Cost Center: 4008
For Agenda of: 4/1/2025
Placement: Public Hearing
Estimated Time: 60 minutes

SUBJECT: REVIEW OF PROPOSED CIRCULATION MODIFICATIONS TO THE

PREVIOUSLY APPROVED 600 TANK FARM ROAD PROJECT, AND ASSOCIATED ADDENDUM TO THE CERTIFIED FINAL

ENVIRONMENTAL IMPACT REPORT

Figure 1: Proposed Interim Transportation Improvements Design Concept: Tank Farm Road

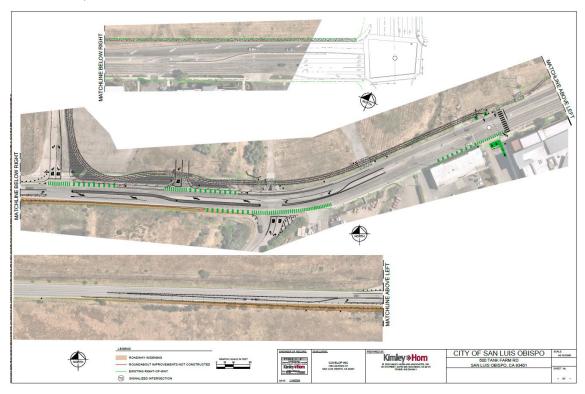
As currently proposed by the developer, the modified project would eliminate the previously planned roundabout at the intersection of Tank Farm Road and Santa Fe Road (West) as an obligation of the development, replacing this project component with a modified/interim access design concept that would provide access to the project site without the roundabout until it can be built in the future by the City or other private development when the required right-of-way is available. Key features of the interim transportation improvements include:

• Tank Farm Road/Santa Fe Road (West) Intersection: Unsignalized, with stop control on the Santa Fe Road (West) approach. Left turns exiting the main driveway at the 600 Tank Farm project would be restricted by a center median on Tank Farm, with only righthand turns onto Tank Farm westbound allowed at this location. Left hand turns from the new Santa Fe Road intersections (both north and southbound) would be allowed via new turn lanes onto Tank Farm Road west and eastbound (Original Approval required construction of the roundabout).

- Minor Road Widening on Tank Farm Road: Widening to add an eastbound leftturn lane into Santa Fe Road (West) and buffered on-street bike lanes along Tank Farm Road.

- Frontage Improvements:
 - Santa Fe Road (West): Landscaped parkway, lighting, street trees, and an elevated (sidewalk-level) two-way shared-use pedestrian/bicycle path on the east side of street only. The shared-use path is to be constructed with permanent materials (concrete) and designed with flexibility to convert to a separate pedestrian sidewalk and one-way northbound protected bike lane in the future by others, which is the ultimate configuration recommended per the ATP. (Original Approval required construction of separate sidewalk and northbound only protected bike lane on the east side of Santa Fe. Modified project provides two-way shared-use path to provide improved bicycle connectivity in the interim until neighboring properties develop and provide internal east-west route for cyclists. Shared-use path design to allow for future conversion to separate sidewalk and one-way bike lane consistent with ATP).

- Tank Farm Road: Landscaped parkway, lighting, street trees, and a two-way shared-use path between Santa Fe (West) and the Mindbody traffic signal. Shared-use path constructed in permanent materials (concrete) along 600 Tank Farm Road frontage, and with temporary (asphalt) east of frontage to the Mindbody signal. The shared-use path is to be designed with flexibility to convert to a separate sidewalk and one-way westbound protected bike lane in the future by others, consistent with the ATP. Tank Farm Road improvements also include widening of the existing culvert at Acacia Creek. (Original Approval required construction of separate sidewalk and west only protected bike lane on the north side of Tank Farm. Modified project provides two-way shared-use path from Santa Fe to Mindbody signal to provide improved bicycle connectivity in interim until neighboring properties develop and provide internal east-west route for cyclists parallel to Tank Farm. Shared-use path design to allow for future conversion to separate sidewalk and one-way bike lane consistent with ATP).

- Temporary Sidewalk: Asphalt sidewalk on street-level along the north side of Tank Farm Road from the Mindbody signal to Broad Street with a protective curb separating pedestrians from vehicle traffic. This provides pedestrian connectivity between the development and Tank Farm Road/Broad Street intersection until permanent sidewalks are constructed by neighboring properties in the future. (No change from Original Approval).

- Traffic Safety Features: Landscaped center median along Tank Farm Road frontage to prevent illegal left turns, acceleration lanes to improve left-turn access to Tank Farm Road from southbound Santa Fe (West) and northbound Santa Fe (East), radar speed feedback signs, striping and warning signage to encourage safer speeds. (Original Approval required construction of roundabout with center median, which provided benefits to traffic calming and access restrictions along project frontage. Modified project features intend to accomplish similar benefits with roundabout now infeasible).

Signal Modifications: Updates to the Tank Farm Road/Mindbody intersection to add pedestrian and bicycle signals phases and bicycle left turn box to improve Tank Farm Road crossings. (Original Approval required addition of pedestrian signals only. Modified project also improves bicycle crossings at this intersection).

The ATC recommendations (1 and 2 above) have been incorporated into the updated improvement design by the applicant, as shown in Figure 1 above and in Attachment C. City staff will monitor the Broad/Tank Farm intersection after project construction, as recommended by ATC (3 above) and signage will be installed if warranted.
